Determination 2010/90

Refusal to issue a code compliance certificate for 7-year-old additions and alterations to a house at 579 Old Tai Tapu Road, RD2, Christchurch

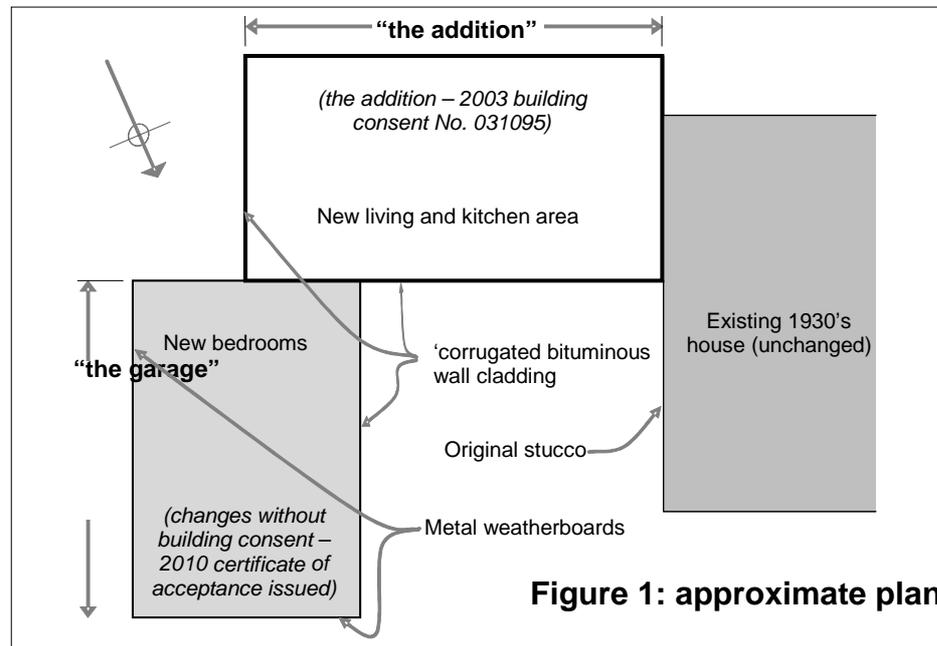
2.2 The building work considered in this determination is shown in Figure 1; and consists of an addition that links the original garage with the house to provide a new living and kitchen area.

2.3 The addition is rectangular in plan and has a 15° pitch gable roof with eaves of about 600mm and verge projections of about 100mm. Construction is conventional light timber frame, with concrete foundations and floor slab, corrugated bituminous sheet wall cladding, aluminium windows and profiled metal roofing. The expert noted no treatment marks on the framing and, given the date of construction in 2003, I consider that the wall framing is likely to be untreated.
